# CITY OF ALBUQUERQUE

PLANNING DEPARTMENT - Development Review Services

RE: Broadstone Promenade, Tract 1, Santa Monica Place Revised Grading & Drainage Plans Engineer's Stamp Date 5-26-2015 (File: D18D054A)

### **SECTION A-A**

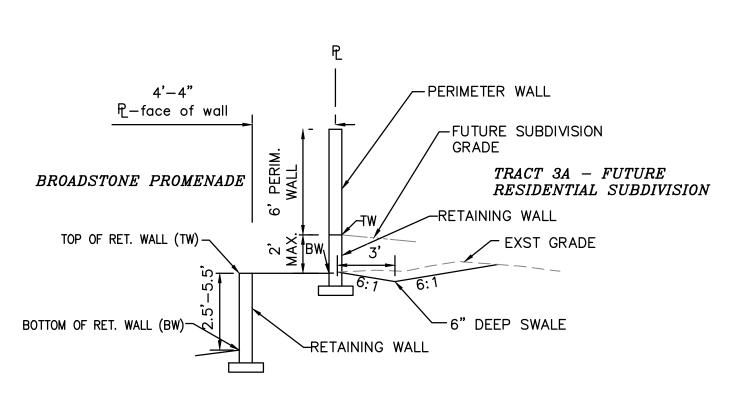
Based upon the information provided in your submittal received 5-25-15, the above referenced plan is approved for Building Permit. It is understood that this revised plan shows the field change made where the storm drain ties into the Manhole in San Pedro rather than the back of the inlet. It also shows the double retaining wall along the east property edge to anticipate future development to the east.

Comment to Rita: Retaining wall revisions at east property line added

Go ahead and approve the Building Permit for Broadstone Promenade (6400 San PedroNE). They are changing the 3' retaining wall along the western edge to a double retaining wall. Although the approved plan does not reflect the change, Asa Nilsson-Weber is going to resubmit the grading plan before submitting the Engineer's Certificate Acceptance.

The reason is that there will be a new subdivision on the tracts to the east. During a grading study for that subdivision, we realized that we needed to increase retaining height and add a double retaining wall to make the grades across the subdivision work. Since the perimeter wall is located on the property line, and the subdivision side is higher, the retaining wall needed to be installed now, prior to the subdivision construction.

The flow line of the swale is offset from the wall, and the amount of water in the swales is minimal (~.2 cfs in each swale) during the 100-yr storm. I determined that erosion control was not necessary in this area because the flow velocity in the swales are non-erosive.

What is the reason for the change? Won't the runoff be running along the wall?

Please see attached for sheet 4 of the G&D plan showing the revised retaining wall layout in blue. We will show the wall revisions on the grading as-built.
